SERVICE BULLETIN

NO. 1628

MODEL Mac 10-10, PM10-10, PM55, 7-10A

SUBJECT Proper Starter Alignment

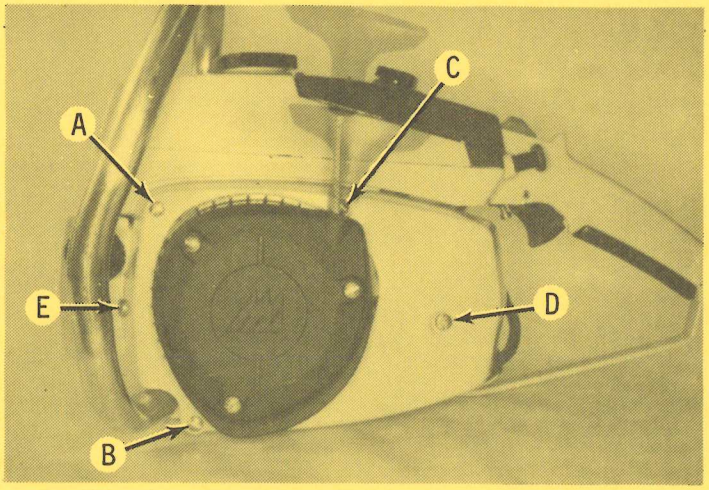
Starter engagement problems in Mac 10-10, Pro Mac 10-10, PM 55, and 7-10A models have been traced to misalignment of starter shaft with starter pawls. To correct this, the following sequence for tightening fan housing fasteners has been established:

A slight dimensional change has been made to the crankcase boss to aid in front screw alignment.

NOTE: For rear screw, the fan housing hole should align with the special stud. If not, file a slot in fan housing hole until proper alignment is achieved.

Any deviation from this sequence will pull starter shaft out of alignment with starter pawls.

1) Tighten three (3) special screws around starter assembly; top front (A) first, bottom front (B) second, and top rear (C) third.

2) Tighten rear fan housing screw (D).

3) Front screw (E) should be tightened last.
